RESPONSE TO COMMENTS

Re: Waterstone Site Plan No 4, DA-1758-10, 4th submittal comments

Please accept this letter in response to your December 2024 review comments on the Waterstone Site Plan No 4, DA-1758-10, 4th submittal comments.

08

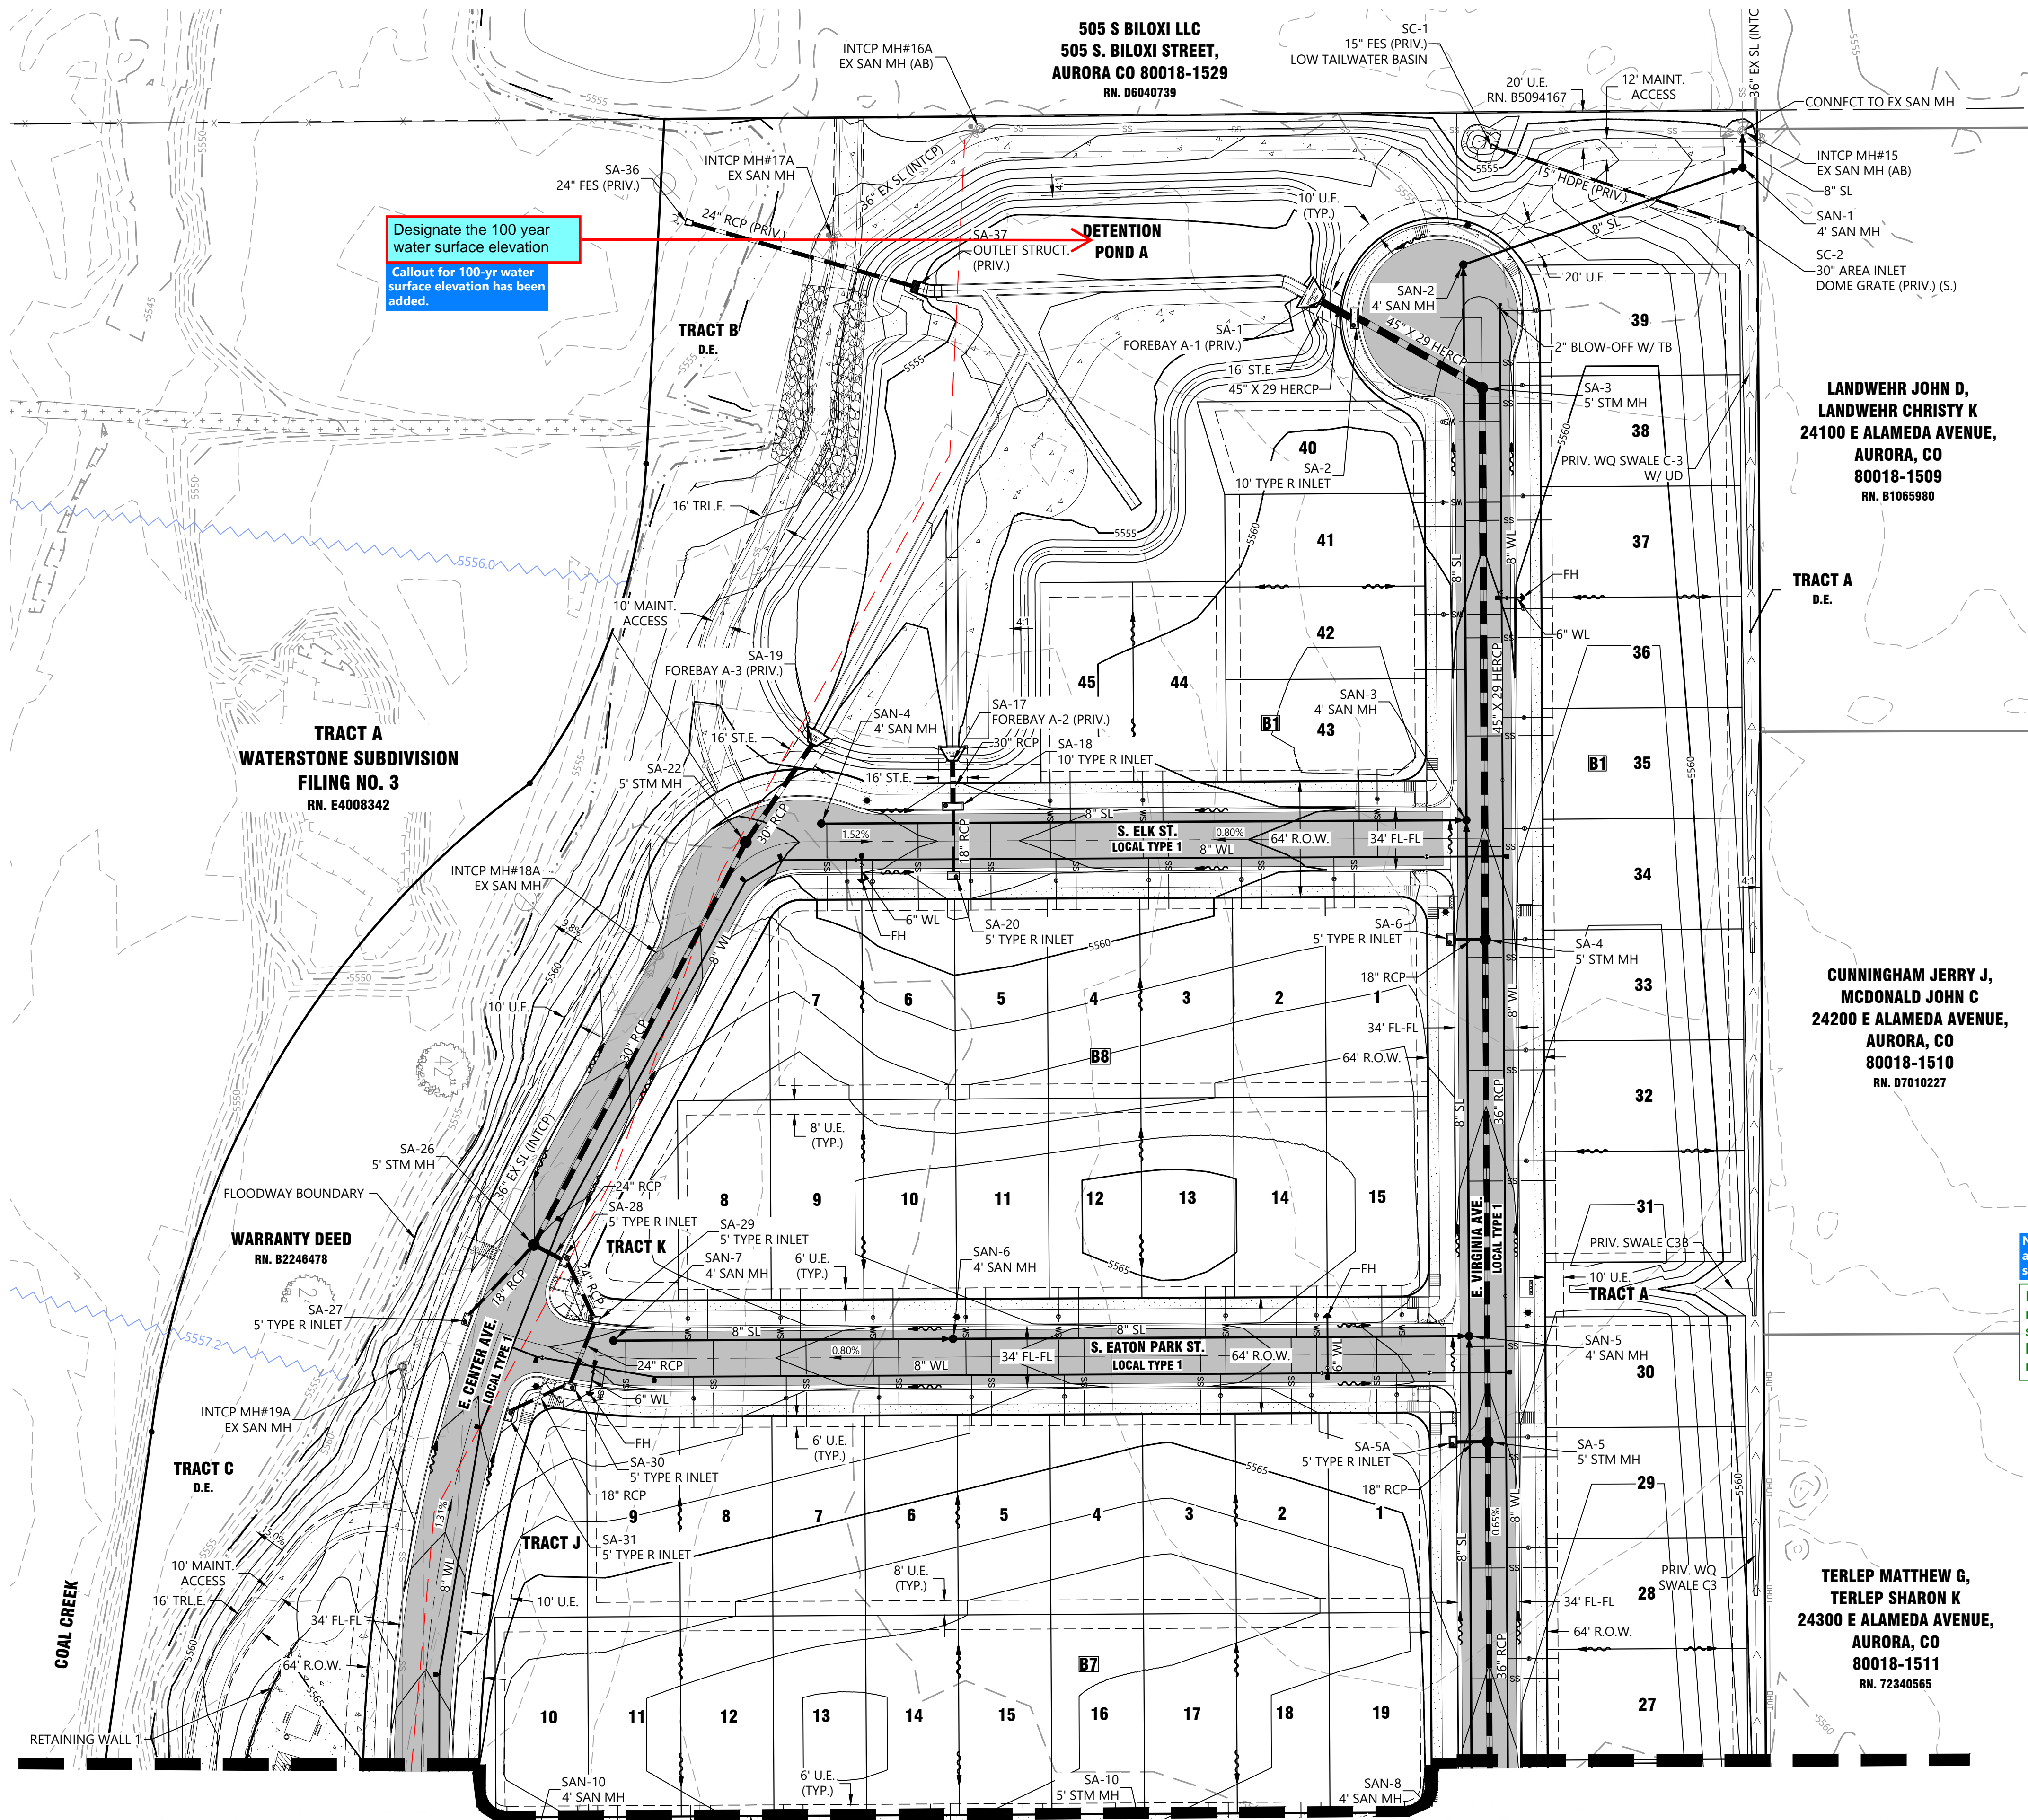
Designate the 100 year water surface elevation
Callout for 100-yr water surface elevation has been added.

No. 10

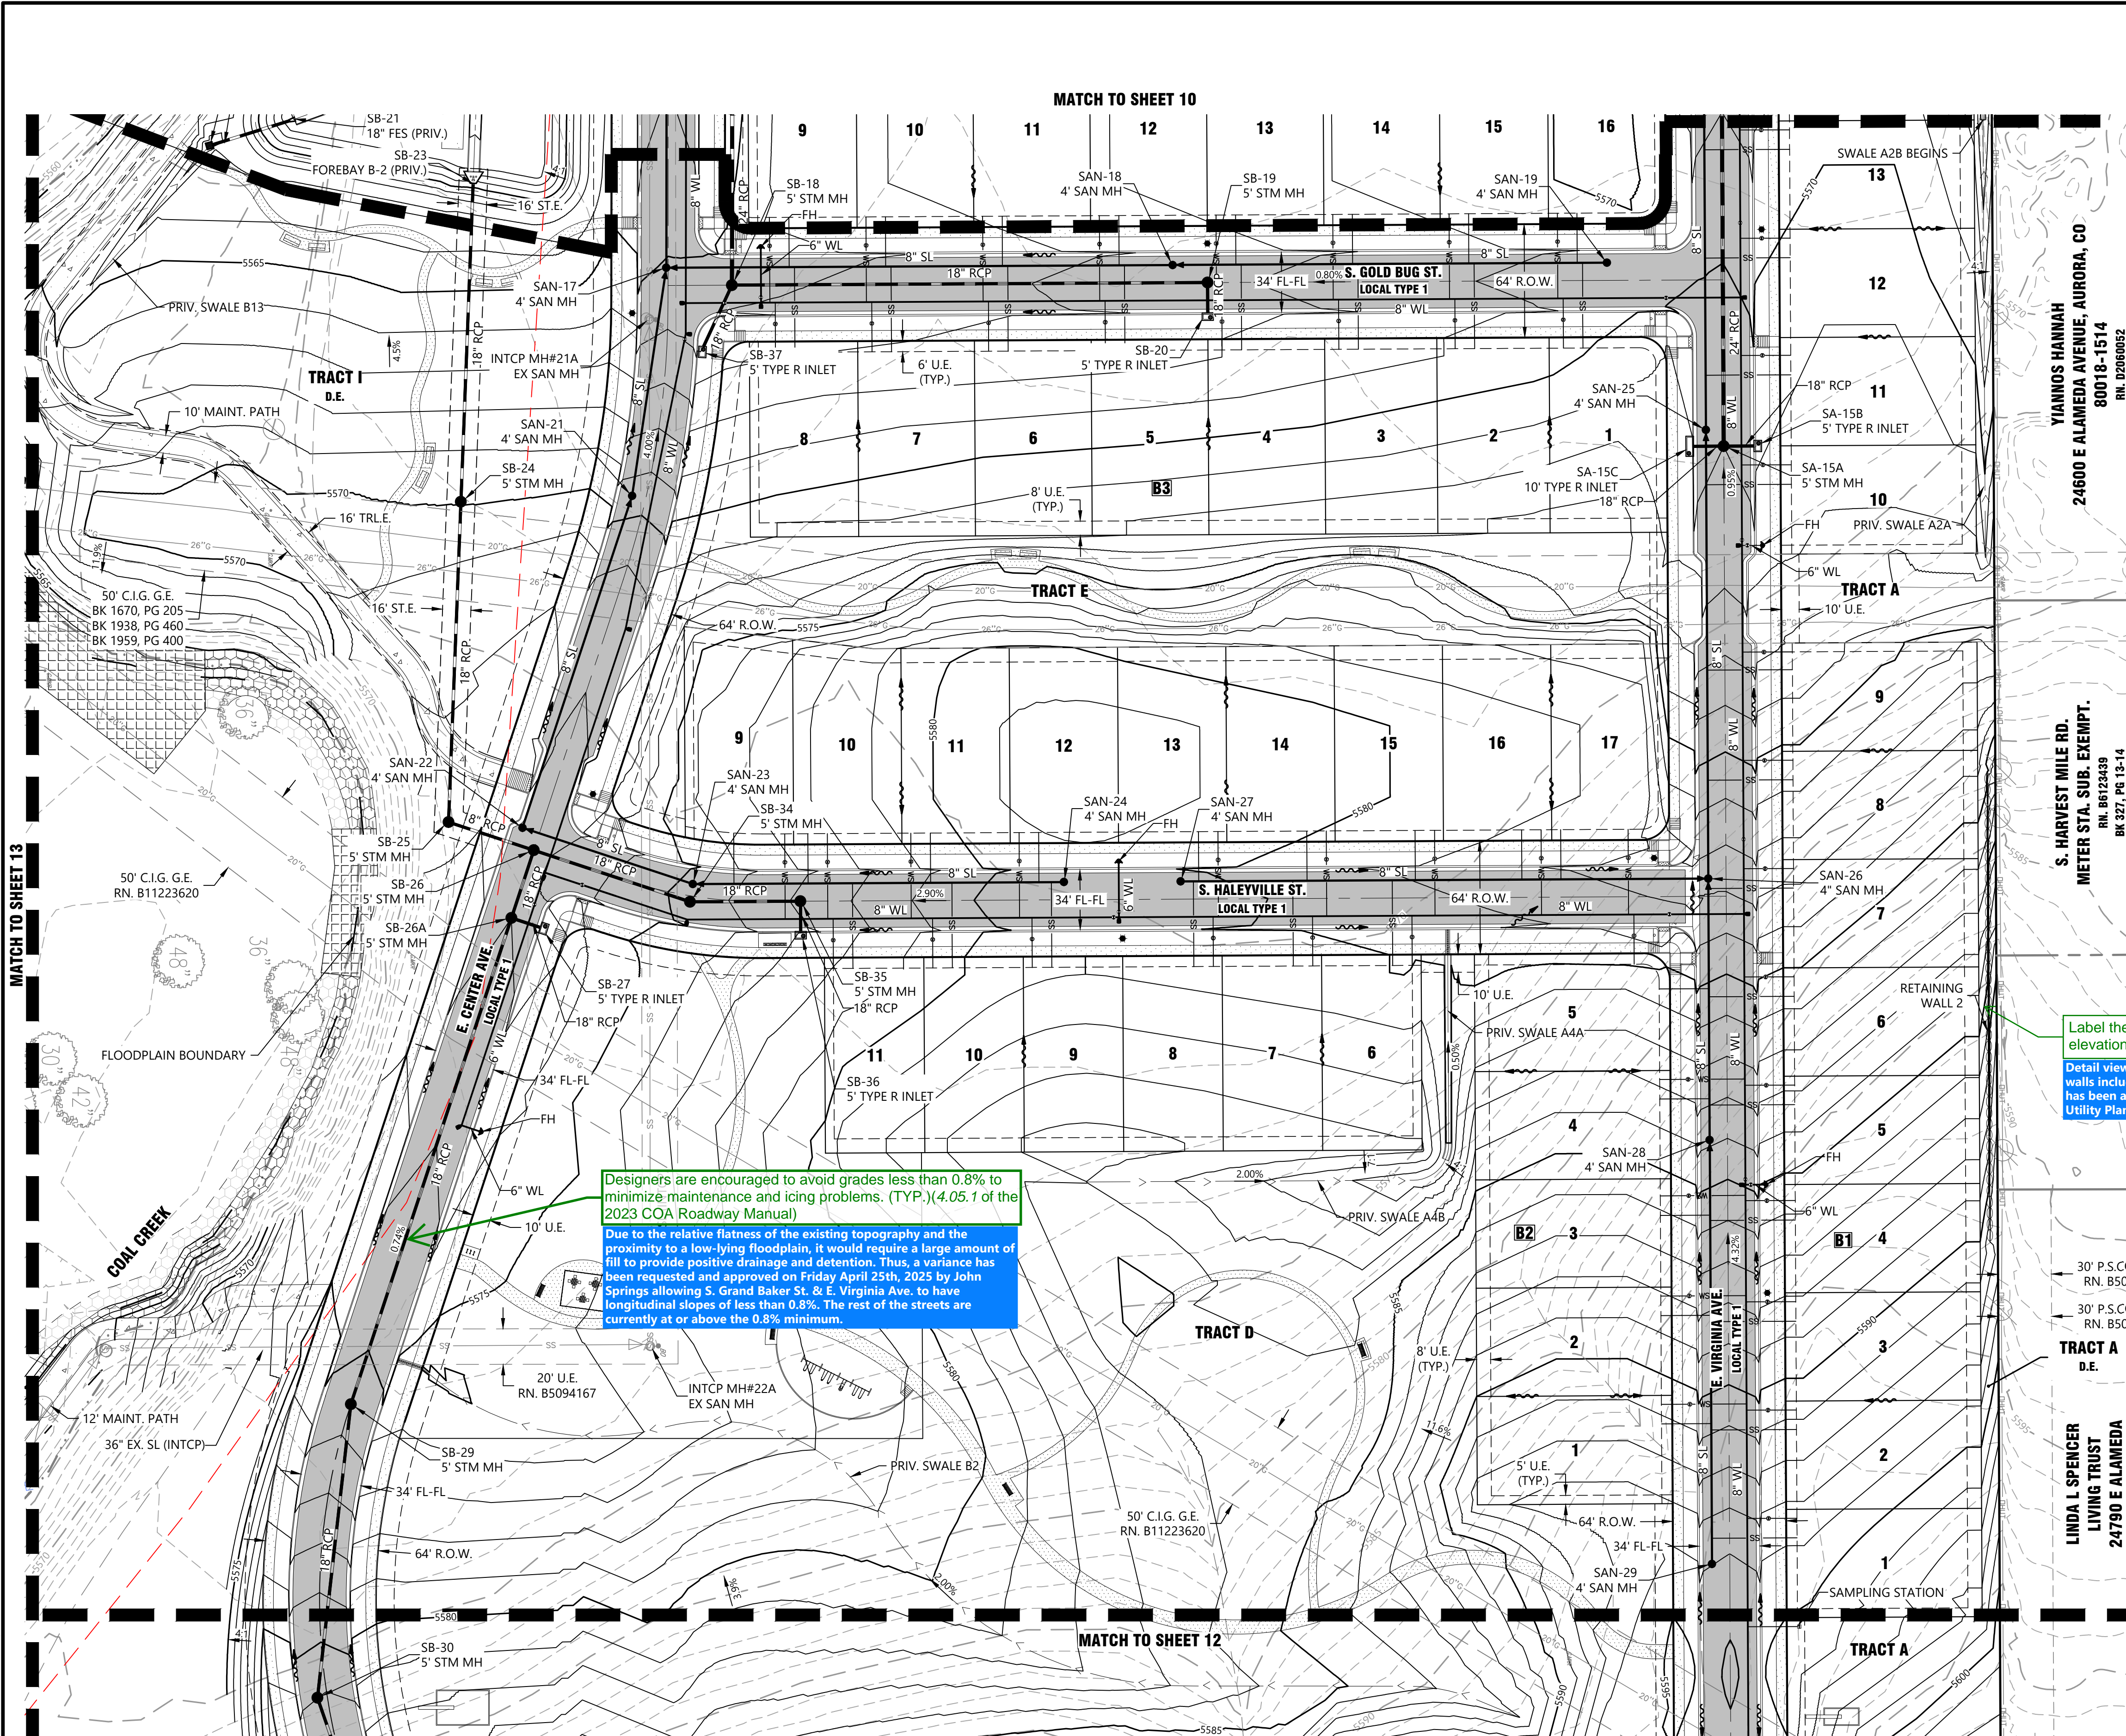
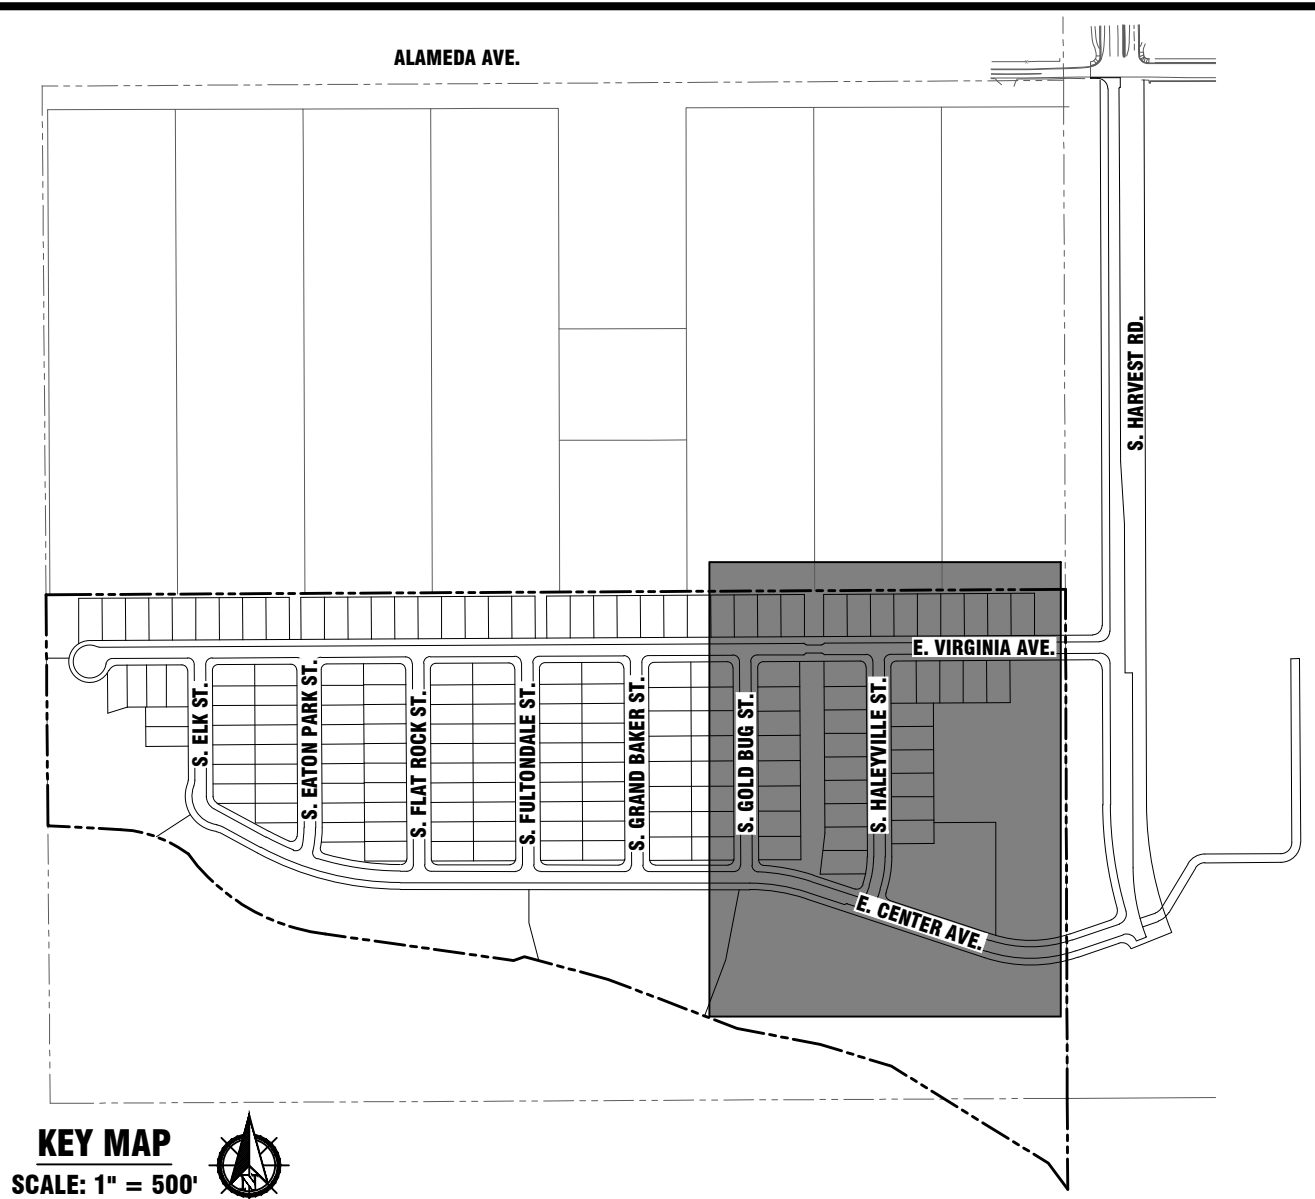
Designers are encouraged to avoid grades less than 0.8% to minimize maintenance and icing problems. (TYP.) (4.05.1 of the 2023 COA Roadway Manual)

Due to the relative flatness of the existing topography and the proximity to a low-lying floodplain, it would require a large amount of fill to provide positive drainage and detention. Thus, a variance has been requested and approved on Friday April 25th, 2025 by John Springs allowing S. Grand Baker St. & E. Virginia Ave. to have longitudinal slopes of less than 0.8%. The rest of the streets are currently at or above the 0.8% minimum.
